Economic Commission for Europe**Inland Transport Committee****World Forum for Harmonization of Vehicle Regulations****158th session**

**1958 Agreement – Consideration of draft amendments
to existing Regulations submitted by GRE****Proposal for Supplement 21 to the 02 series of amendments
to Regulation No. 7 (Position, stop and end-outline lamps)****Submitted by the Working Party on Lighting and Light-Signalling***

1. Front position lamp

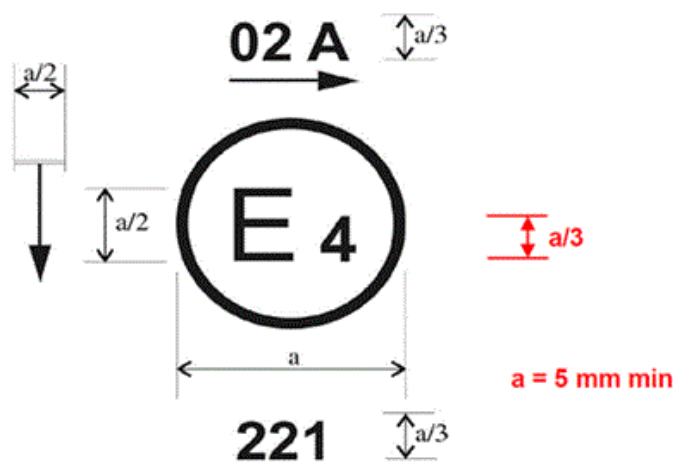
Annex 3, paragraph 1., amend to read:

The device bearing the approval mark shown above is a front position lamp approved in the Netherlands (E4), under approval number 221 pursuant to Regulation No. 7.

The number mentioned close to the symbol "A" indicates that approval was granted in accordance with the requirements of Regulation No. 7 as amended by the 02 series of amendments. The horizontal arrow indicates the side on which the required photometric specifications are met up to an angle of 80° H. The vertical arrow starting from a horizontal segment and directed downwards indicates a permissible mounting height of equal to or less than 750 mm from the ground for this device."
